# Access Compliance Report

## Public Rights-of-Way

### (Pedestrian Signals)

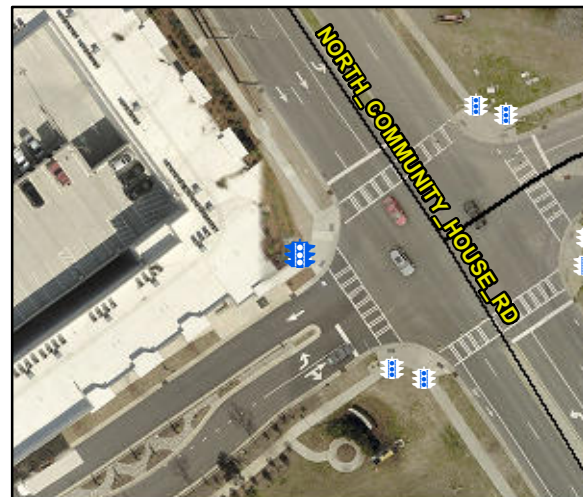
Intersection ID: N/A	Main Street:	Cross Street: N/A	Location: N/A
ADA ID: 46F34FA815D3	Signal Type: One Push Button-Non APS	Overall Compliance: No	Severity Score: BTN 1: N/A BTN 2: N/A No BTN: N/A
Codes/Mitigation Info/Possible Solution		Field Measurements/Component Compliance

PROW/ADA: TMUTCD 4e.08, R404.2, R404.3, R406.2

Possible Solutions: Replace Signal Push Button With APS Button on New Post. Remove & Relocate Sign.
